Bidding and Contract Requirements
Addendum No. 1

Date: June 2, 2021
To: Plan Holders
Subject: Addendum No. 1 to the Bidding Documents for: ITB No. 2021-003

Satellite Jail HVAC Replacement Project
502 South Lierman Avenue
Urbana, Illinois

SHEET:
M-201

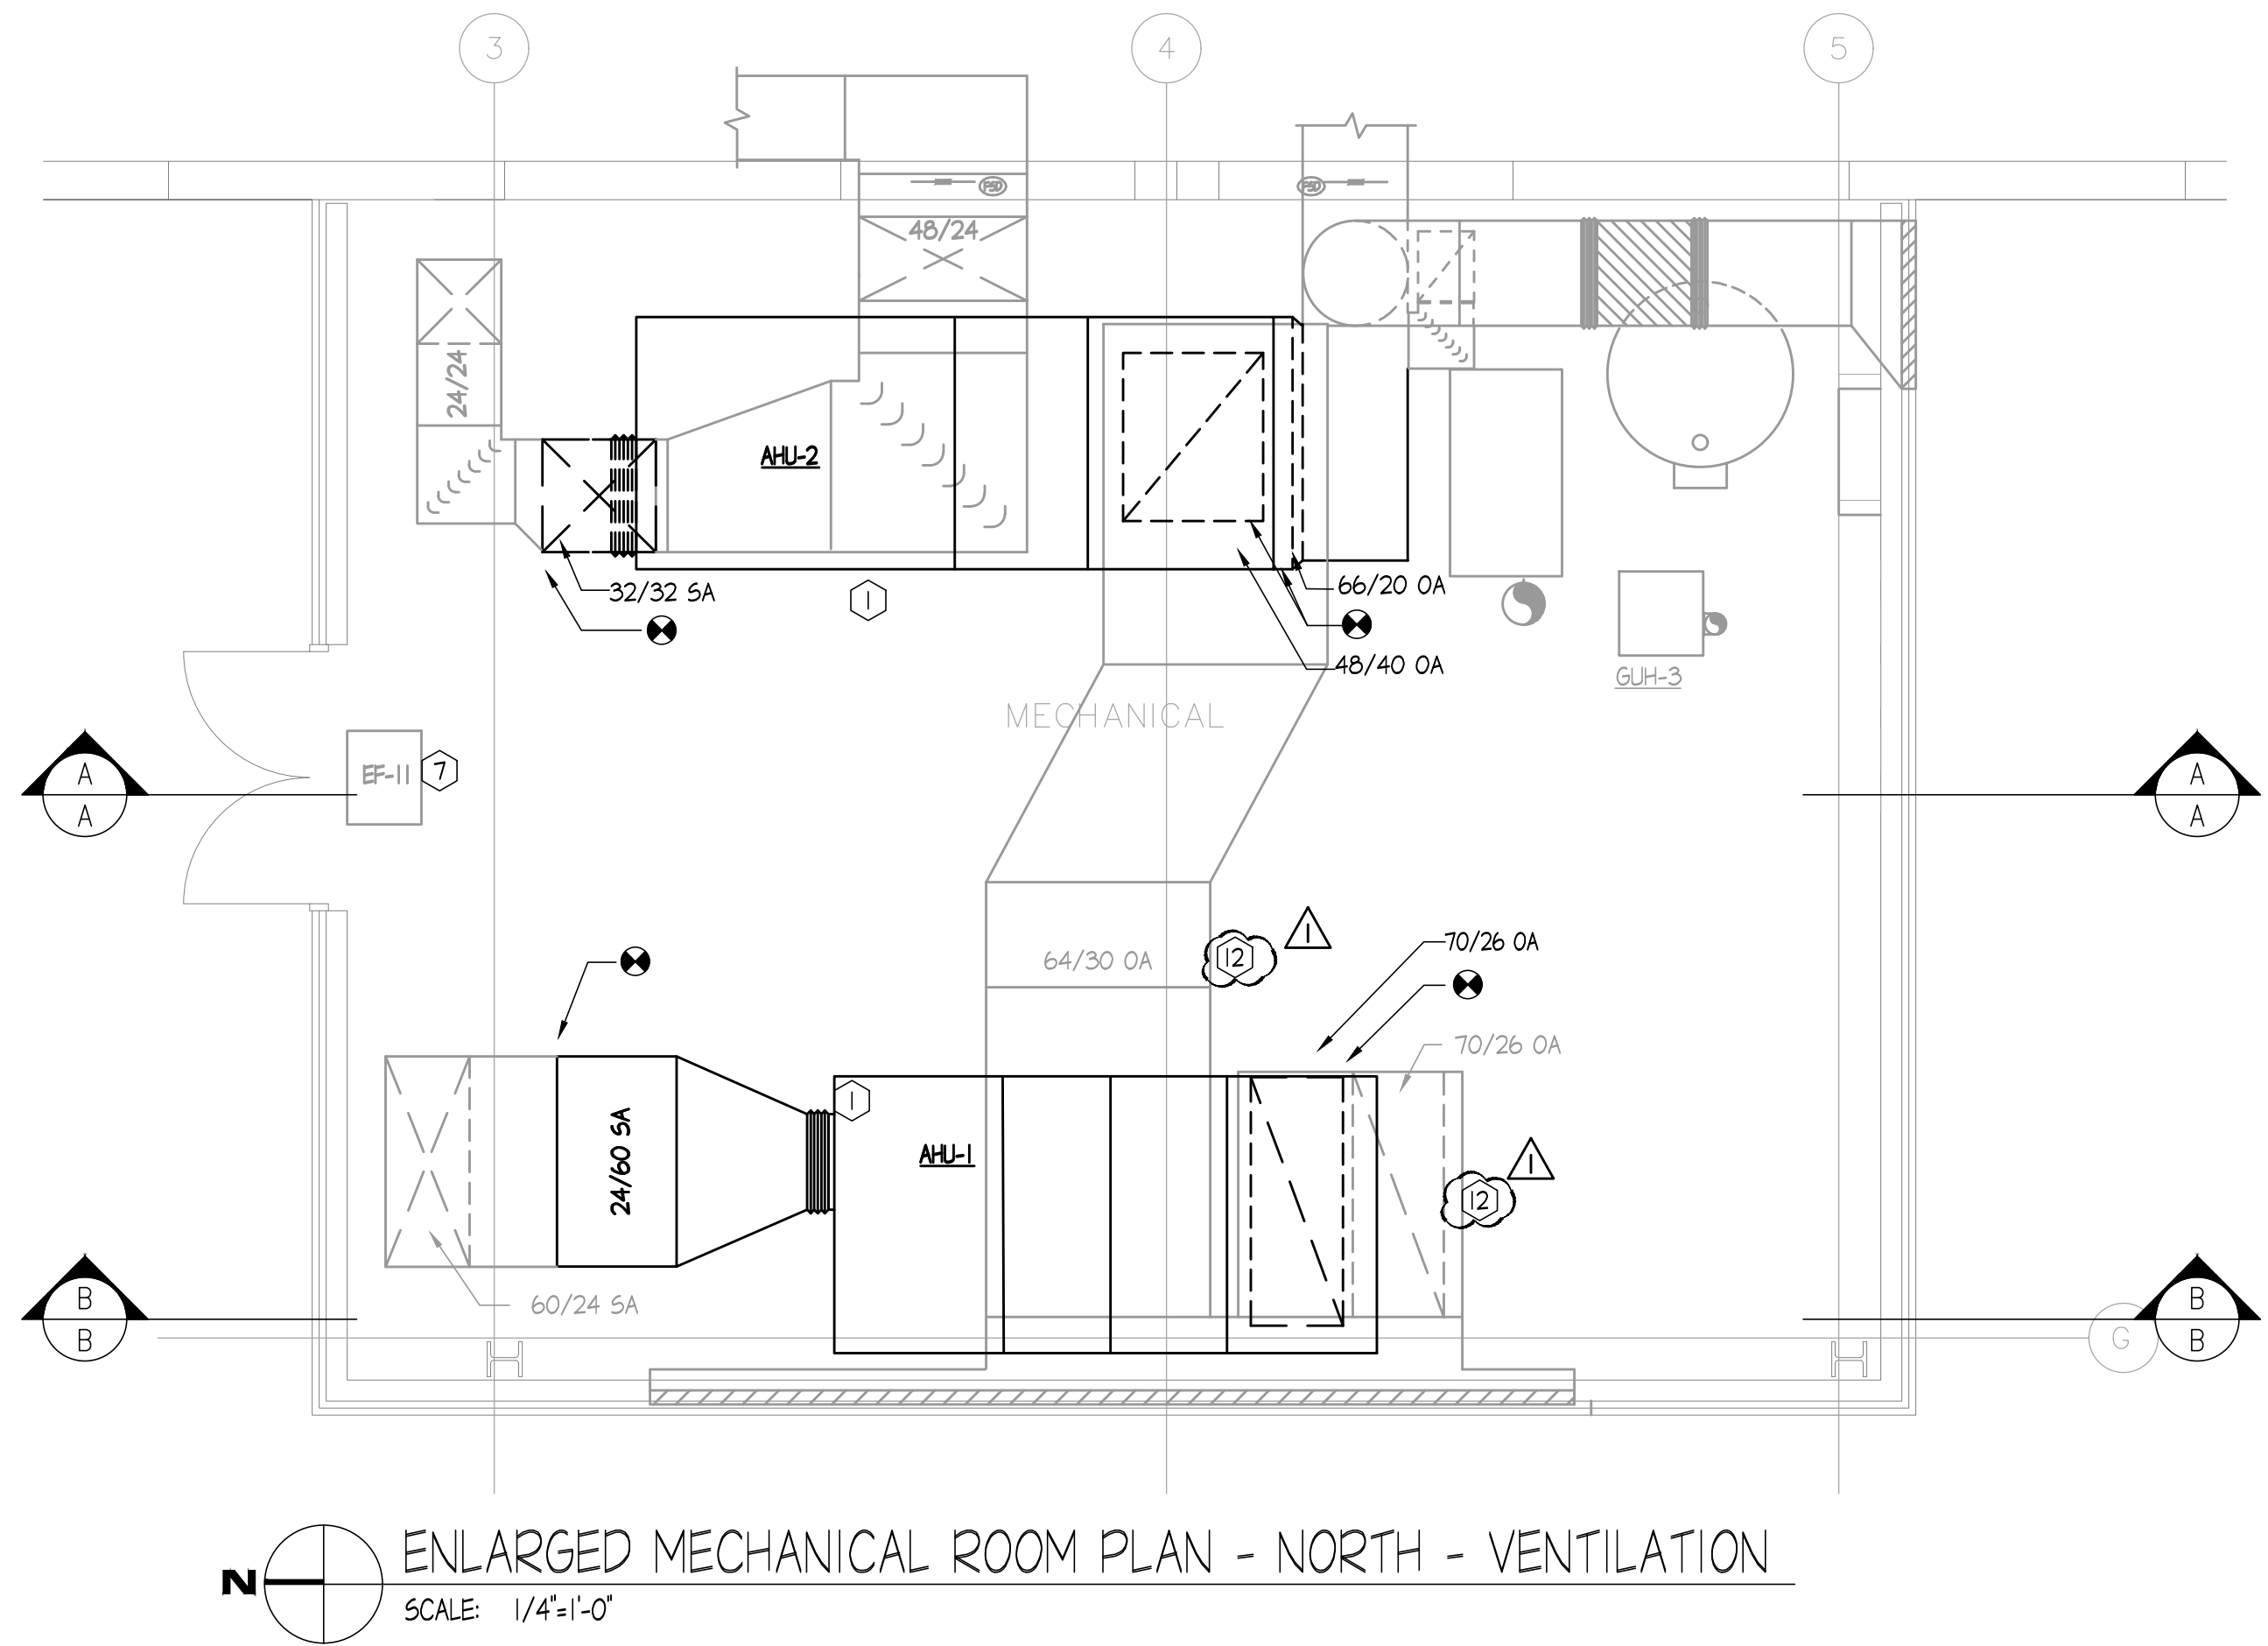
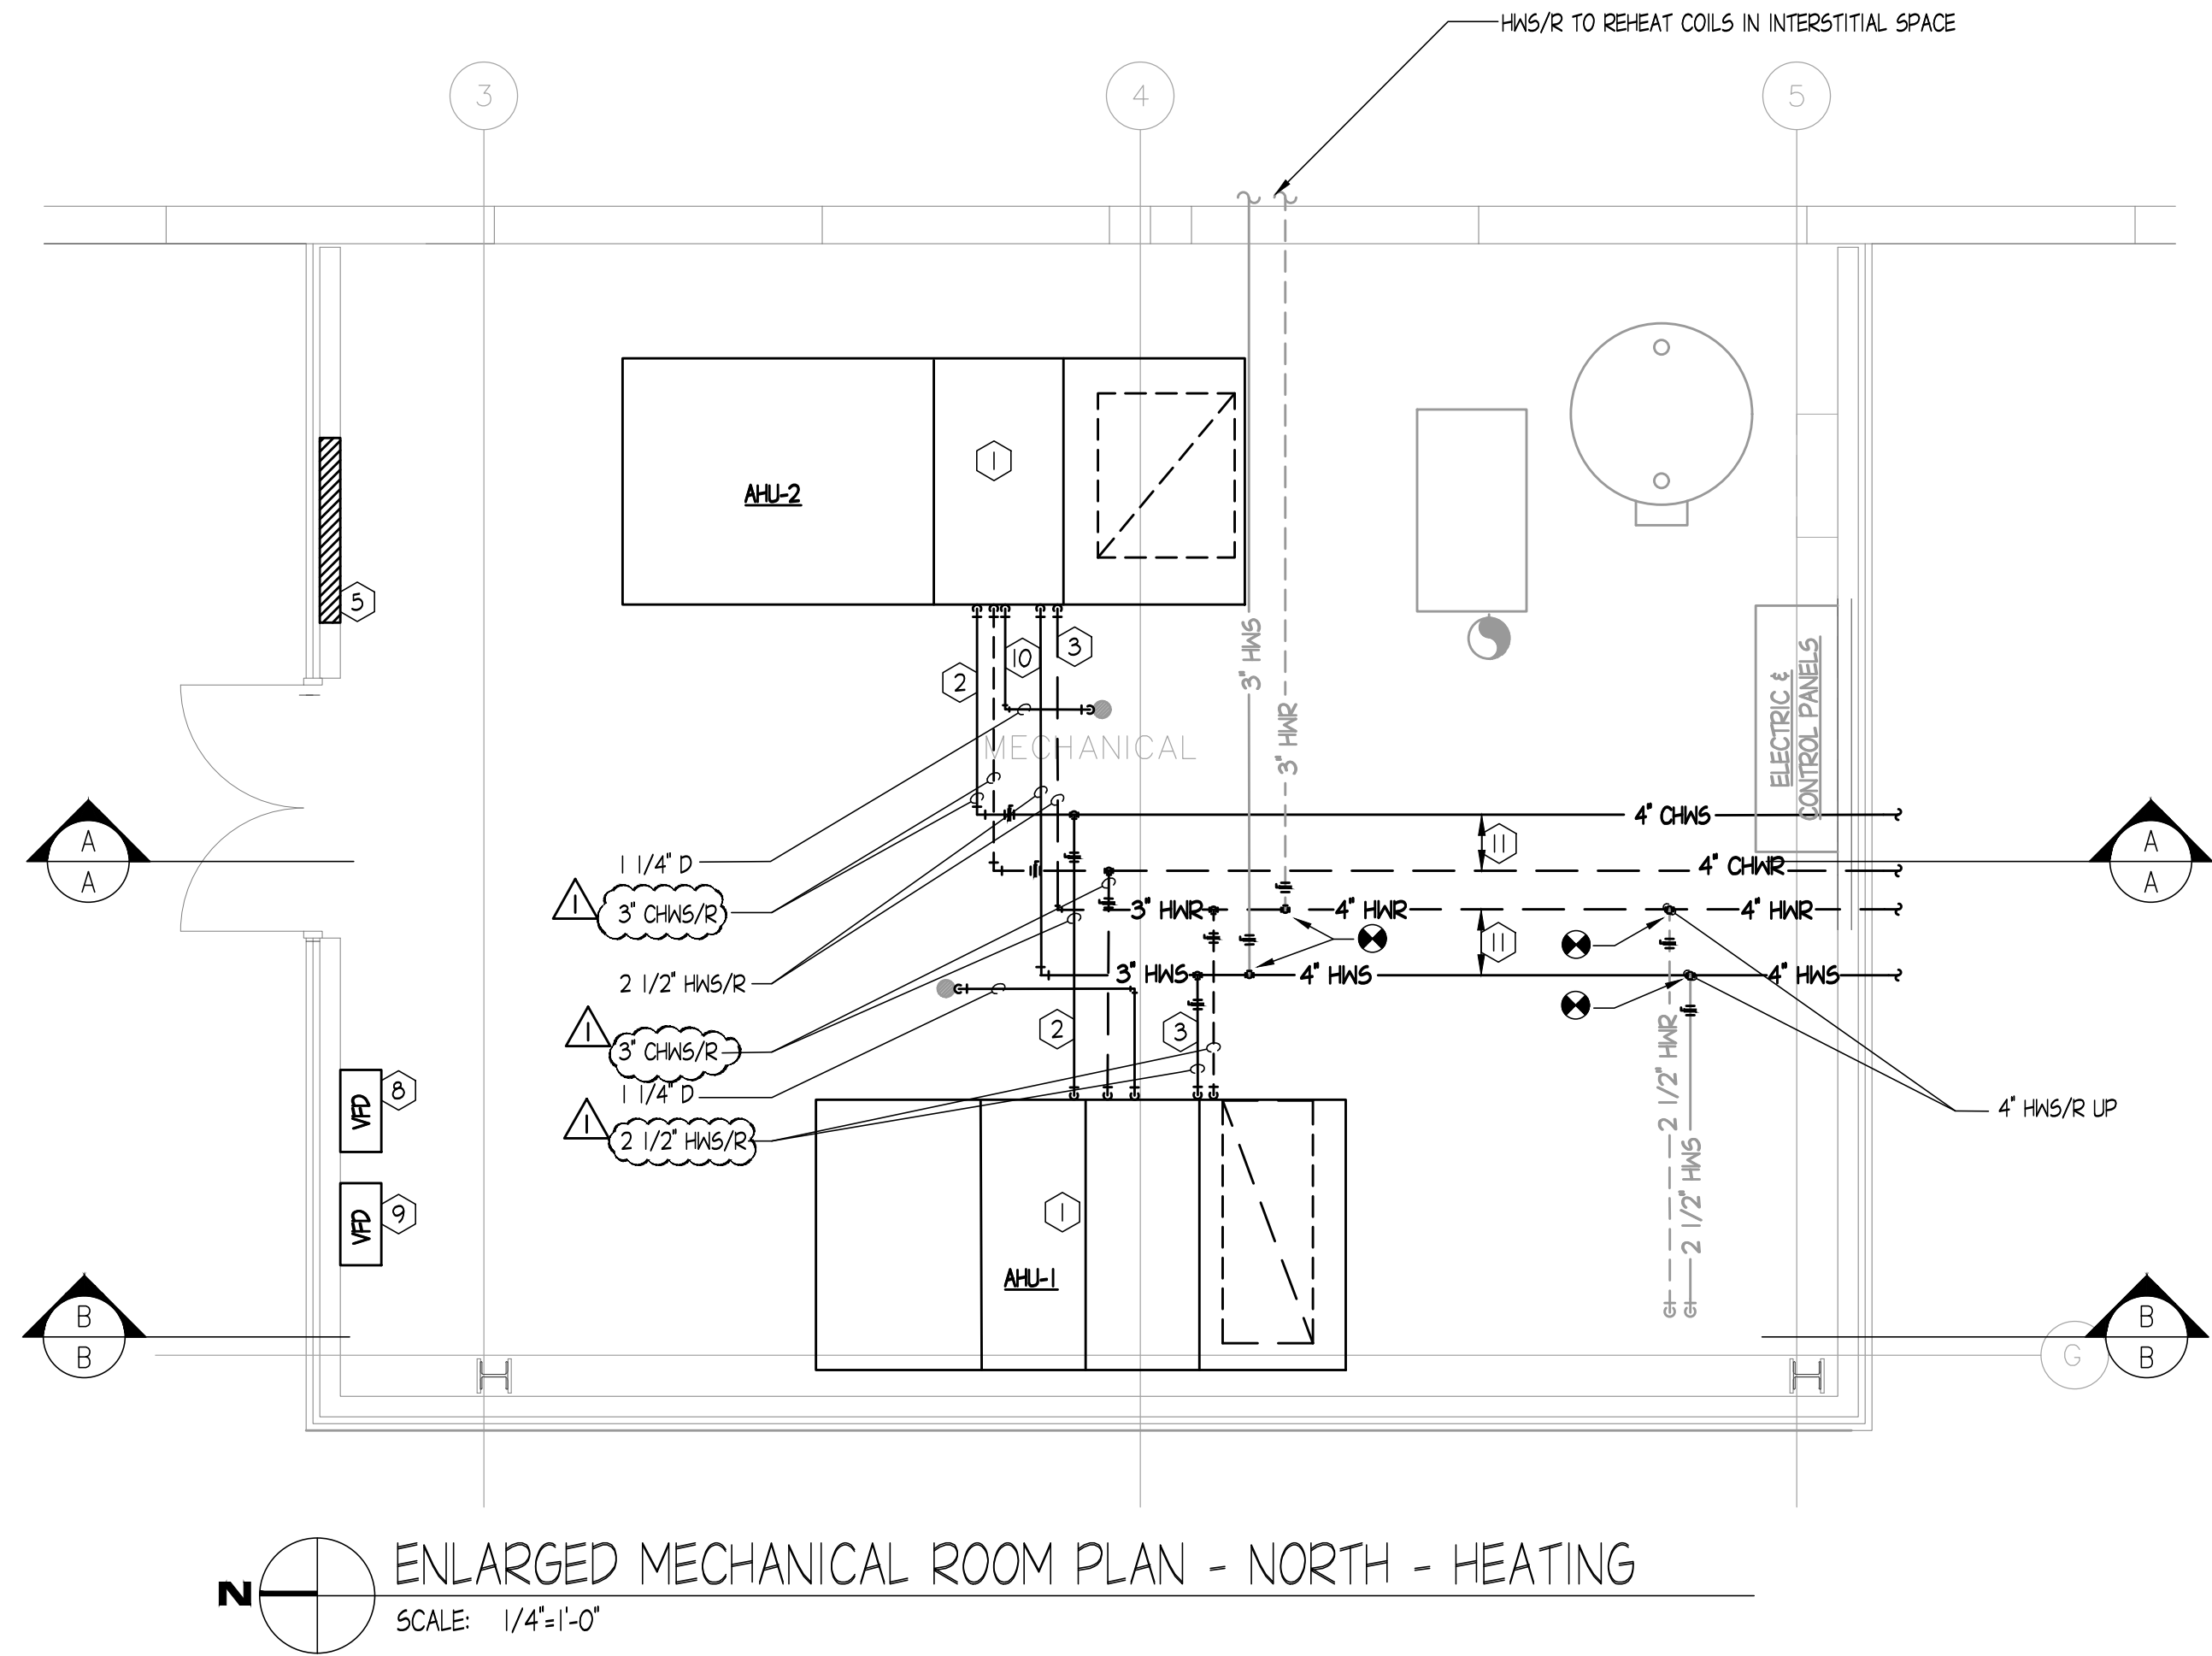
4. Sheet M-201 - ENLARGED FLOOR PLANS - HVAC
 - a. REVISE piping sizes. See attached sheet.
 - b. ADD note for installation of Air Measuring Stations. See attached sheet.
5. Sheet M-202 - ENLARGED FLOOR PLANS - NEW PENTHOUSE - HVAC
 - a. REVISE piping sizes. See attached sheet.
 - b. ADD note for installation of Air Measuring Stations. See attached sheet.
6. Sheet M-400 - SCHEDULES - HVAC
 - a. REVISE AHU schedule. See attached sheet.
7. Sheet M-500 - CONTROLS DIAGRAMS - HVAC
 - a. REVISE control drawing details. See attached sheet.
 - b. ADD note to read "Note: Coordinate base bid contract work with control contract work per control drawings."
8. Sheet S-100 - STRUCTURAL DETAILS
 - a. ADD penthouse structural steel details. See attached sheet.
9. Sheet E103 - ROOF PLAN - ELECTRICAL
 - a. REVISED keyed note regarding panel 'PH2A' to no. 13. There had been (2) keyed notes numbered no. 14.

- KEYED NOTES -** (FOR THIS PLAN ONLY) (SYMBOL)
- ① INSTALL NEW AHU ON EXISTING HOUSEKEEPING PAD
 - ② CONNECT NEW CHWS/R PIPING TO NEW AHU. FOR COIL CONNECTIONS SEE DETAIL M-300
 - ③ CONNECT NEW HWS/R PIPING TO NEW AHU. FOR COIL CONNECTIONS SEE DETAIL M-300
 - ④ CONNECT NEW AHU TO EXISTING SA, RA & RA DUCTWORK.
 - ⑤ INSTALL NEW CONTROL PANEL.
 - ⑥ EXTEND OA DUCT INTO PENTHOUSE. TURN OA DUCT VERTICALLY TO NEW ROOF HOODS ON PENTHOUSE.
 - ⑦ EXISTING EF TO REMAIN. REPLACE EXISTING ASSOCIATED CONTROLLER. FOR CONTROLS WORK SEE DETAIL. PROVIDE START/STOP. M-500
 - ⑧ NEW VFD SERVING AHU-1.
 - ⑨ NEW VFD SERVING AHU-2.
 - ⑩ NEW CONDENSATE PIPING FROM AHU TO FLOOR DRAIN.
 - ⑪ INSTALL DIFFERENTIAL PRESSURE SENSOR. SEE DETAIL M-300
- △ AIR MEASURING STATION PROVIDED BY TEMPERATURE CONTROL CONTRACTOR AND INSTALLED BY MECHANICAL CONTRACTOR.
